This document is prepared by the IEEE 802.1Qcr editor (Johannes Specht) for the upcoming comment resolution of P802.1Qcr/D1.0 during the TSN TG call on June 17<sup>th</sup> 2019.

## Comment #101 (high priority, with preview)

Figure 8-17—Frame timing at gate-close events

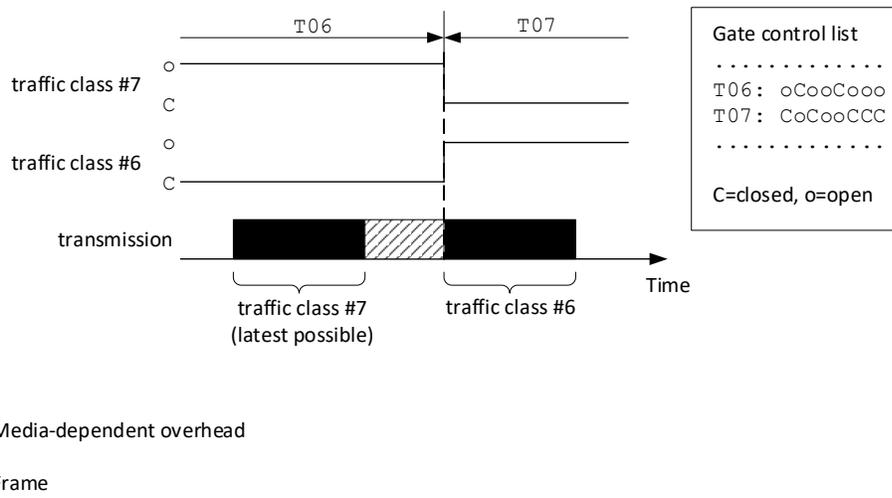
Replace the text in the second sentence of 8.6.8.4 as follows, "...entirety of that frame, plus the media-dependent overhead specified in (12.4.2.2), ..."

Include an informative Note. The recommended text for a note is below - editor to adjust as needed

"NOTE: For example, in the case of 802.3, the media-dependent overhead includes, the preamble of the following frame so that the close of a transmission window can coincide with the opening of another transmission window"

The editor is encourage to include a figure to depict the timing and the alignment of the overhead as well.

ACCEPT IN PRINCIPLE.

Text&Figure will be crafted by the Editor/contributors for the next WG ballot draft.

Change the paragraph below Table 8-7 and subsequent NOTE 1, located on page 204 of IEEE Std 802.1Q™-2018, as indicated in red, Insert new Figure 8-17 as shown, and add new NOTE 1 as shown, renumber as necessary:

In addition to the other checks carried out by the transmission selection algorithm, a frame on a traffic class queue is not available for transmission [as required for tests (a) and (b) in 8.6.8] if the transmission gate is in the closed state or if there is insufficient time available to transmit the entirety of that frame, plus the media-dependent overhead specified in 12.4.2.2, before the next gate-close event (3.97) associated with that queue (Figure 8-17).

NOTE 1—For example, in case of IEEE 802.3 media, the media-dependent overhead prior to the gate-close event includes the preamble of a potentially following frame from a different traffic class.
